MEMPHIS AND SHELBY COUNTY OFFICE OF PLANNING AND DEVELOPMENT

STAFF REPORT

CASE NUMBER: UV 09-07 **L.U.C.B. MEETING:** December 10, 2009

REQUEST: A use variance to permit parking within the R-S6I Zoning District located behind the existing building at 2953 Broad Avenue to serve a proposed medical clinic

Proposed Site Plan

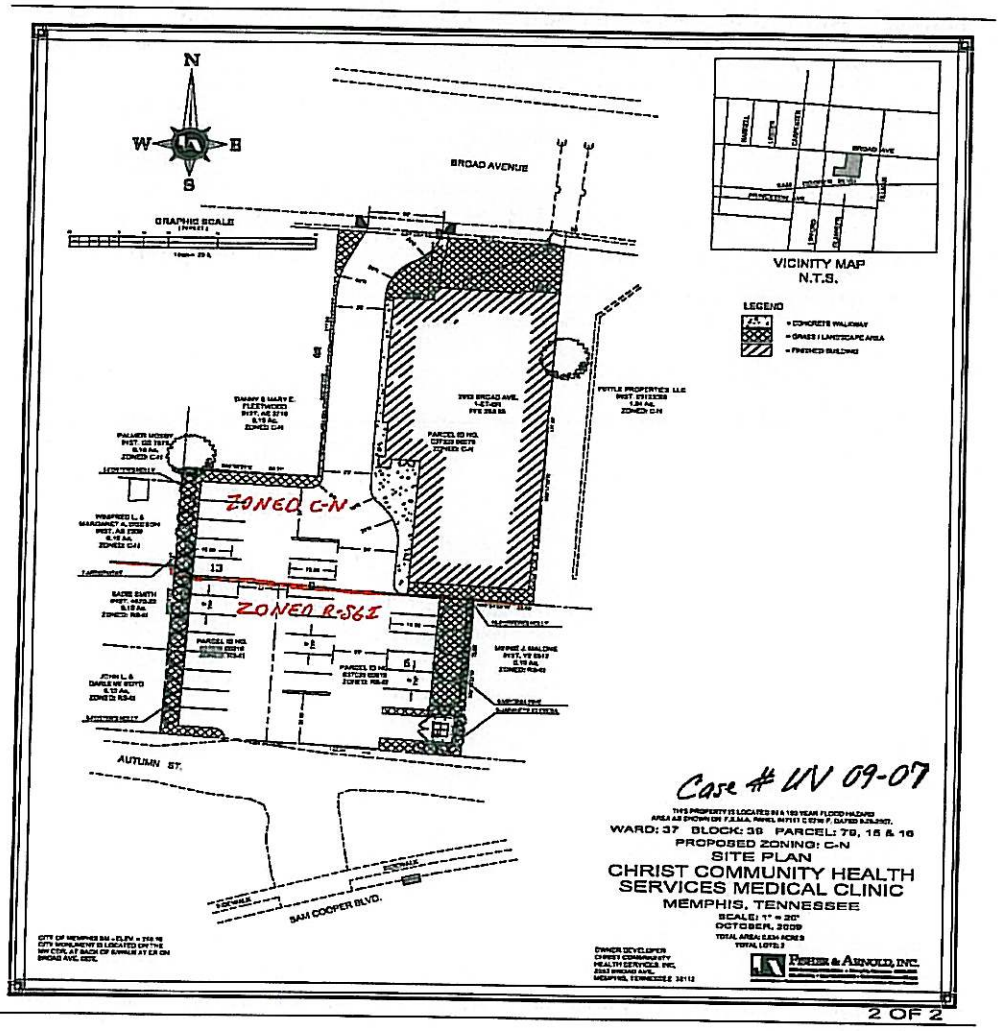
The use variance requested for the parking lot can be supported provided it is designed correctly. On Page 6 of this report, the applicant proposes edge screening in the form of evergreen shrub and tree species along the east and west property lines abutting the existing single-family homes. These homes currently have chain-link fencing installed, so it is agreeable that planting tightly-spaced evergreens will suffice here in lieu of adding a sight-proof fence.

3. A Modified B-Series Landscaping Plate or equivalent shall be provided along the east and west property lines of the parking lot. Existing chain link fencing may be used to meet any fencing requirement. All landscaping species installed shall be evergreen varieties subject to the approval of the Office of Planning and Development. A minimum planting width of 7 feet shall be provided.

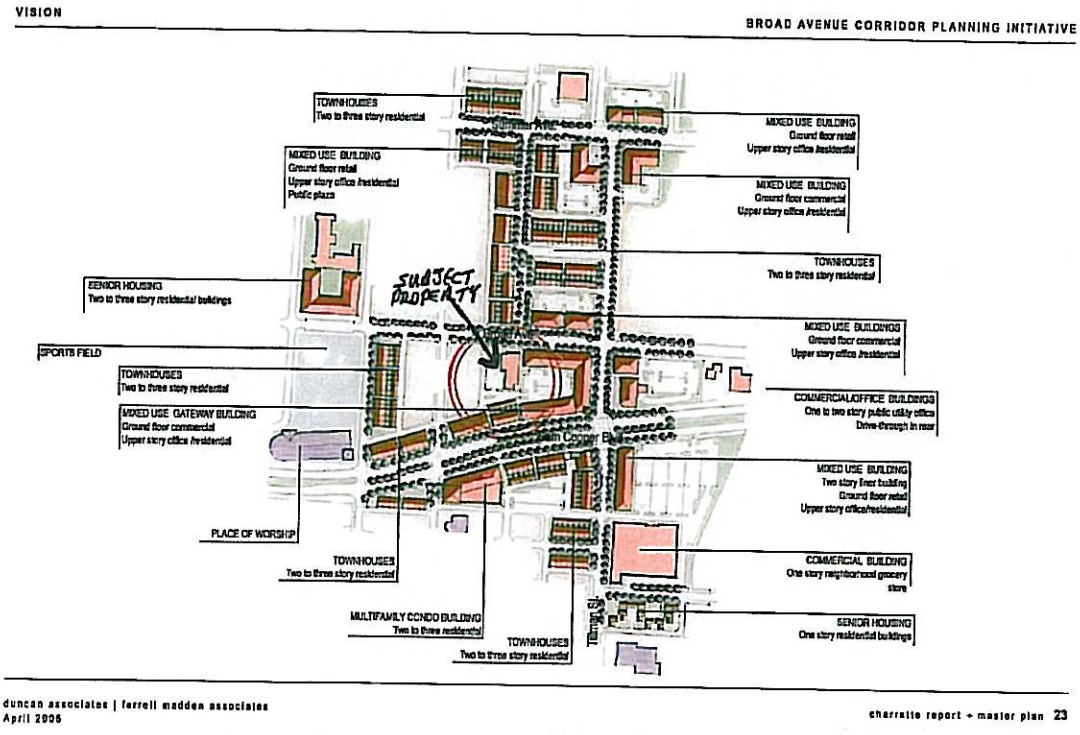
The Broad Avenue Corridor Planning Initiative Charrette Report and Master Plan supports the use of this area as a parking lot as is illustrated.

The proposed parking lot is in a small pocket of R-S6I Zoning that frankly may be difficult to redevelop for single-family homes simply due to the proximity of Sam Cooper Boulevard to this area and limited property available. On Page 17 of this report, a graphic prepared as part of the Broad Avenue Corridor Planning Initiative seems to support this as it calls for mixed uses to be developed here that includes permitting the parking lot area in question.

ELEVATION

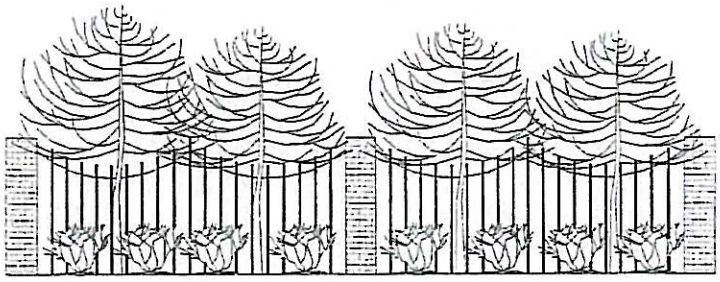
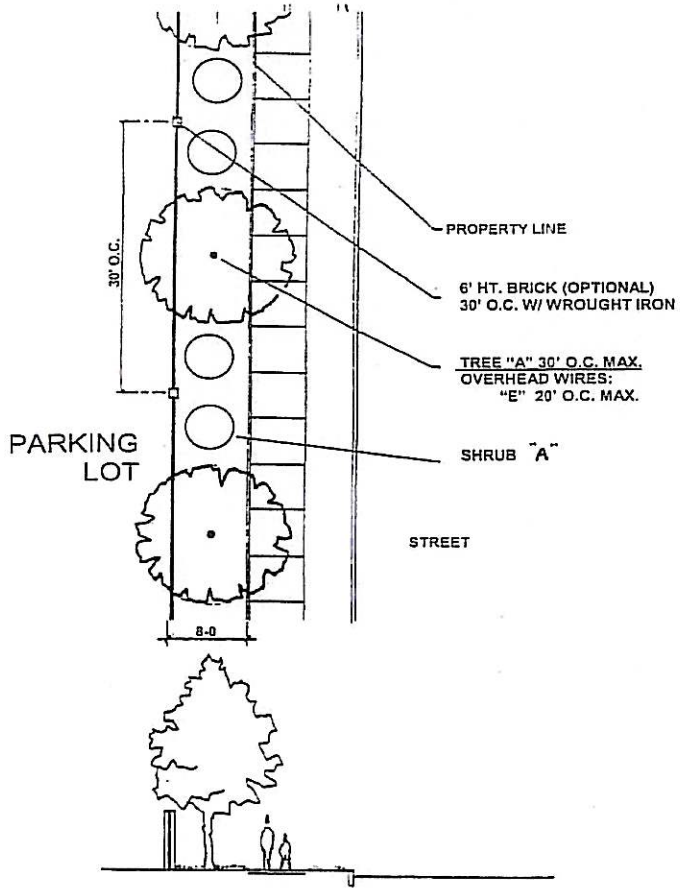
A proposed screening treatment such as this should be provided at the rear of the parking lot along Autumn Avenue/Sam Cooper Boulevard.

One of the most important screening improvements to be established will be along Autumn Avenue at the rear of the parking lot. The existing parking lot area is easily visible from Sam Cooper Boulevard. As is illustrated on Pages 18 and 19, an existing church near the subject property has established a standard for screening parking lots along Sam Cooper Boulevard. Something similar to this or the sketch on Page 19 will be expected to be constructed by the applicant.

4. Autumn Avenue shall be fenced using a wrought iron fence with brick or other suitable material columns and include landscaping in the form of shrubs and trees subject to the approval of the Office of Planning and Development. A minimum planting width of 8 feet shall be provided.
